RS-14-173

Quad Cities Nuclear Power Station, Units 1 and 2
Renewed Facility Operating License Nos. DPR-29 and DPR-30
NRC Docket Nos. 50-254 and 50-265

Subject: Response to Request for Additional Information Regarding Fukushima Lessons Learned - Flood Hazard Reeevaluation Report

Regarding Fukushima Lessons Learned - Flood Hazard Reevaluation Report

Figure 16.1: HEC-RAS Cross Sections Locations on Top Of Topographic Map (Cross Section 522.5 to 512.7)

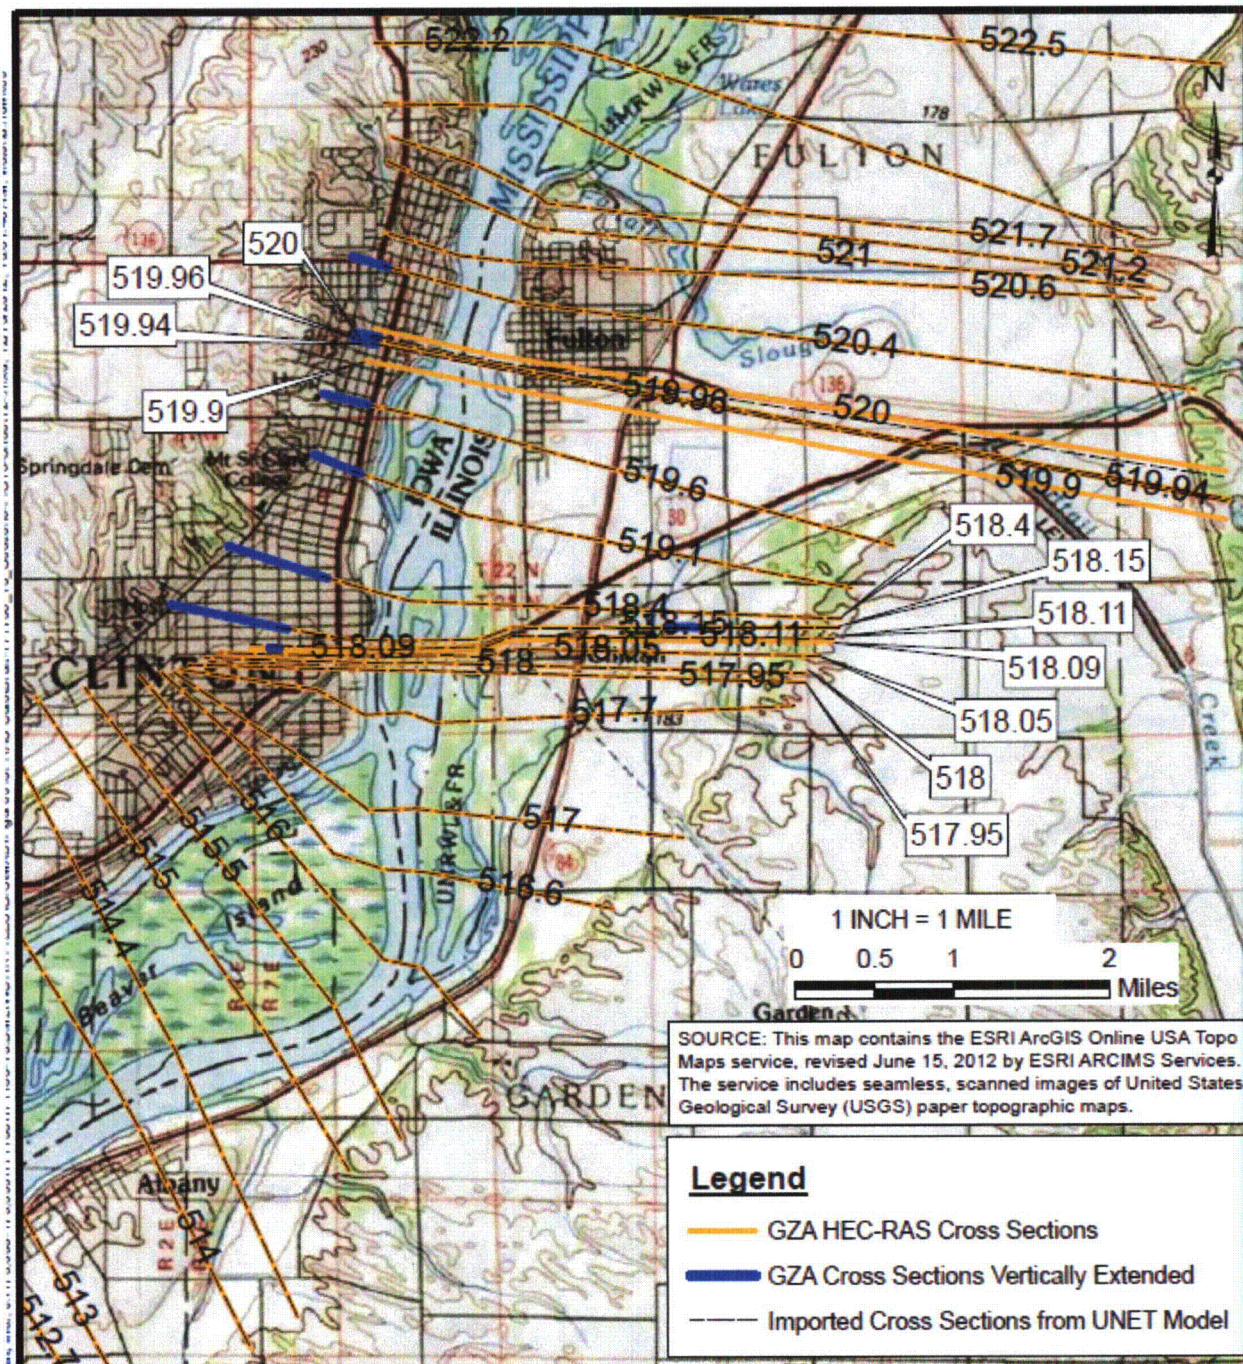
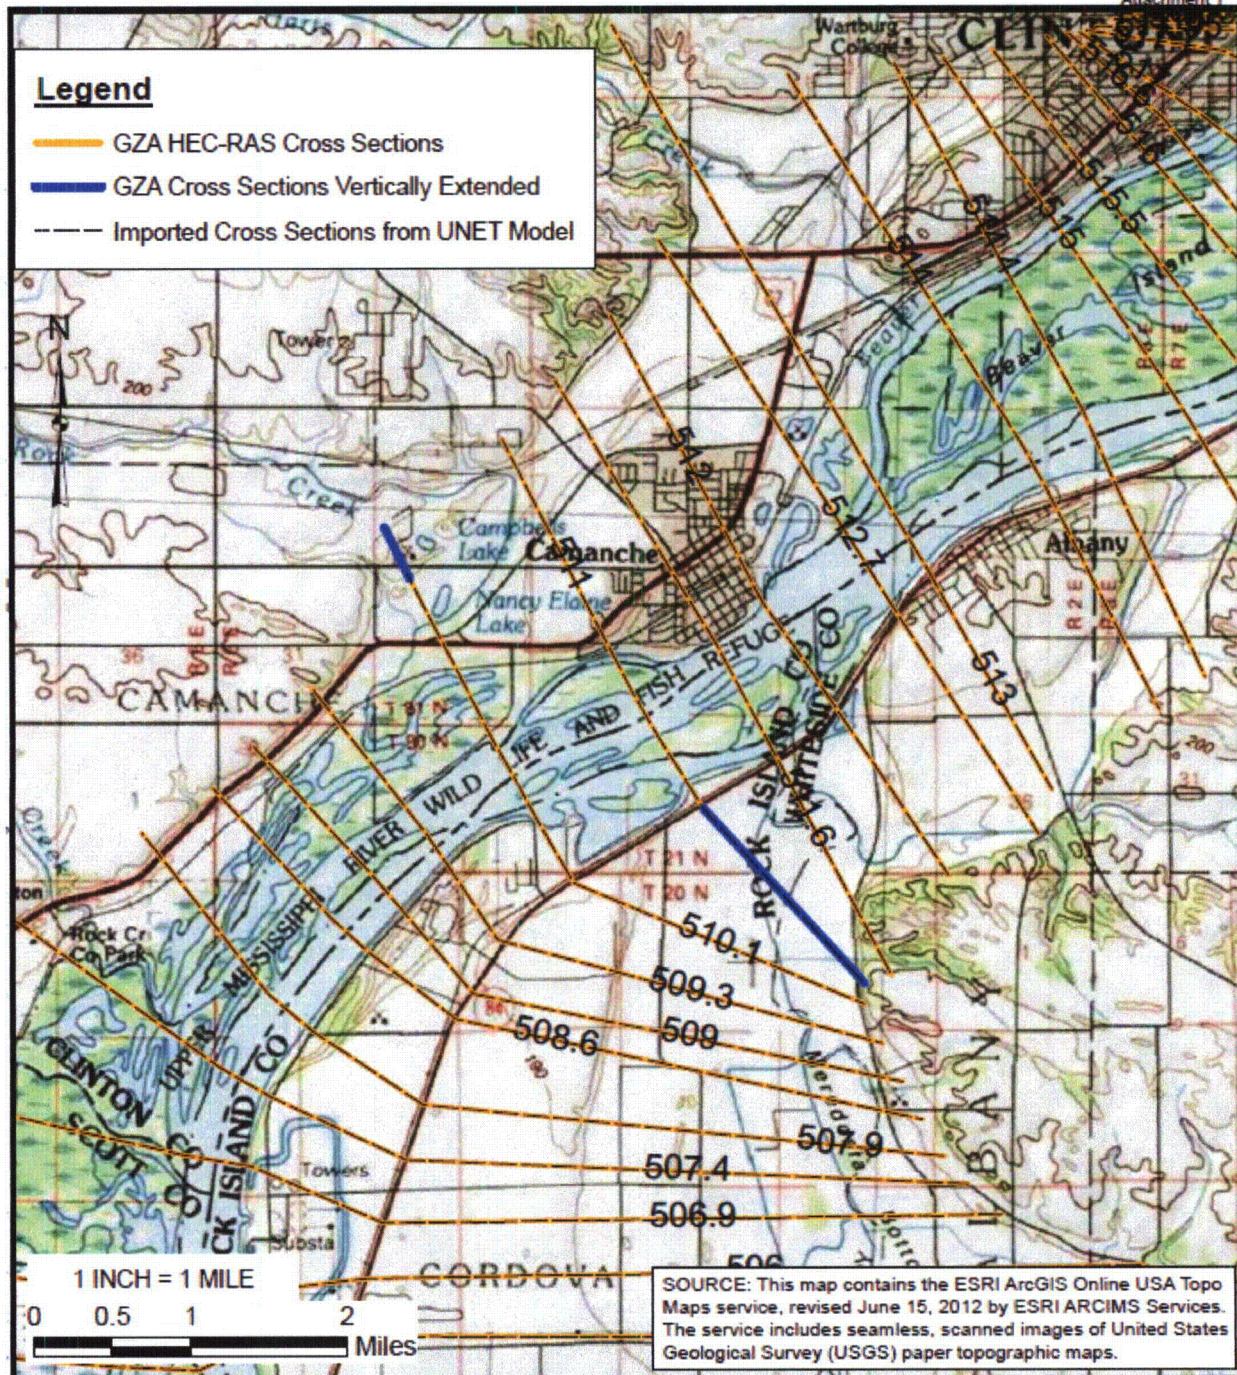
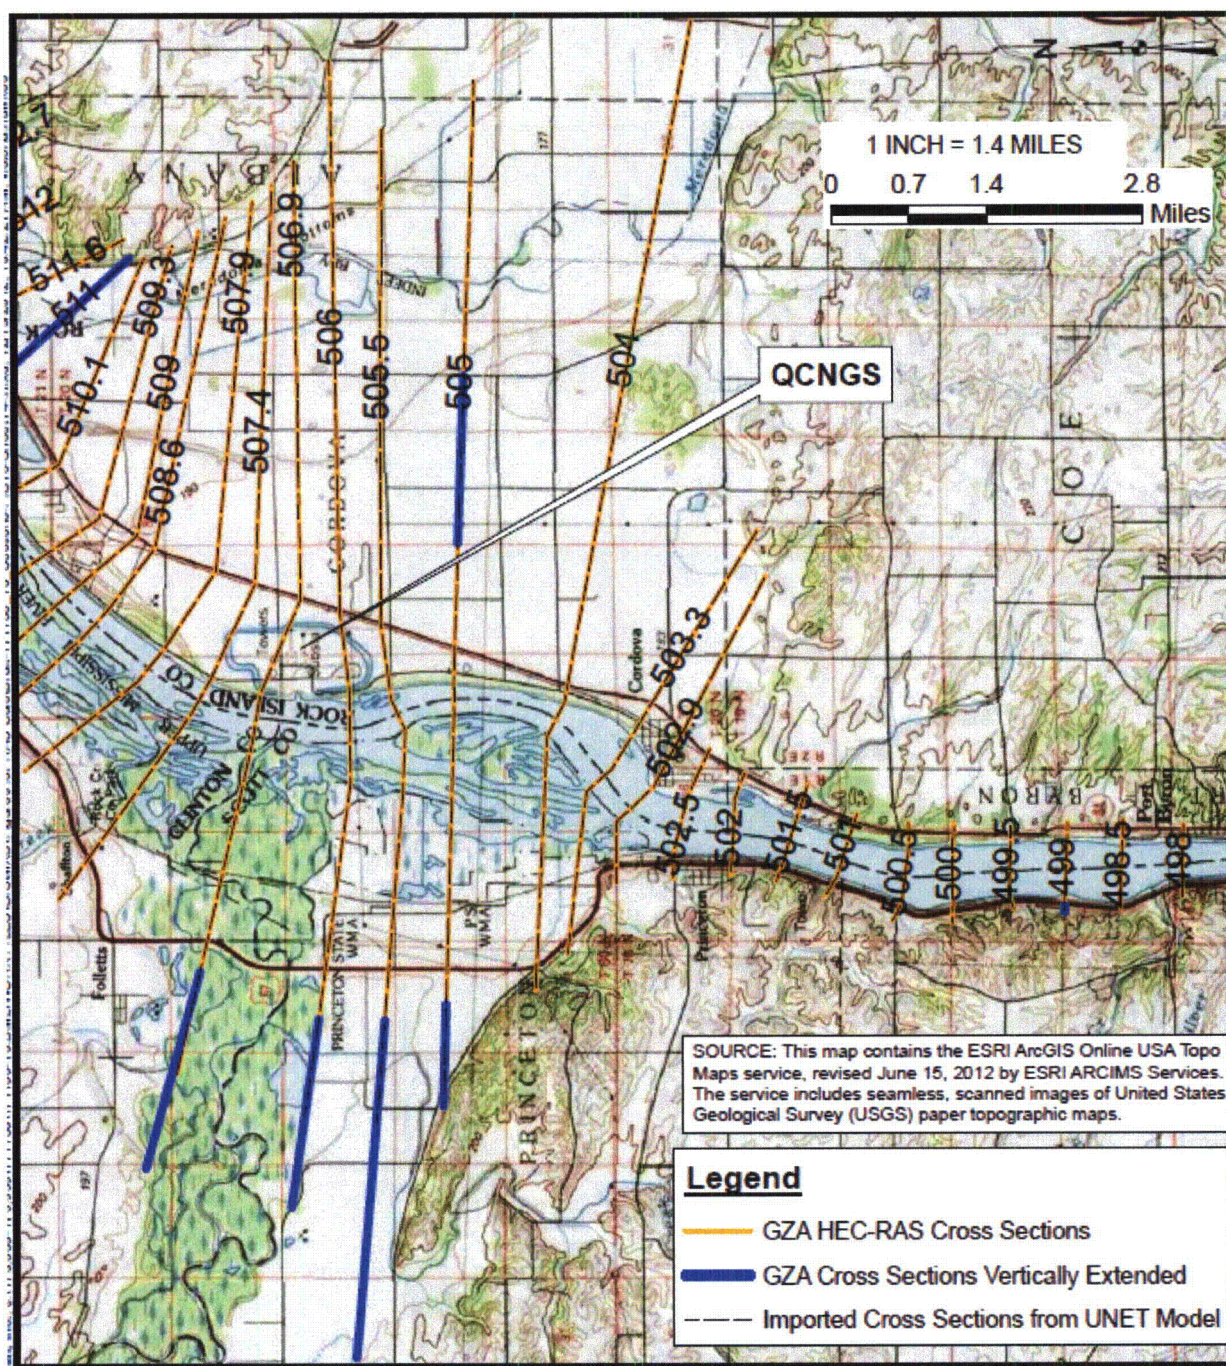
Request: Provide additional details on the initial and final values of Manning's n roughness coefficient, and describe how those values compare with recommended values in standard references for site conditions existing in the watershed. For example, provide a table similar to Table 1 in the LIP evaluation report, which includes the type of surface coverage and the extent of coverage.

As discussed above, for some cross sections the lower end of Manning's roughness coefficients from Chow, 1959 were used. However, for calibration purposes, the Manning roughness coefficients were adjusted to better match computed profiles to observed historical water surface elevations. The results of the QCNPS HEC-RAS model calibration (Table 16.2) show that four of the simulated calibration floods (1965, 2001, 1993, and 1969) generated a peak water surface elevation at QCNPS within 0.5 foot of the observed elevations, and one calibration flood (1997) slightly exceeded the target elevation difference by 0.2 foot (i.e., +0.7 foot difference between simulated and observed). Based on the calibration results, the QCNPS model is judged to be acceptably calibrated. Using the higher end values would be more conservative, but the results would deviate from observed elevation and would not be considered sound calibration.
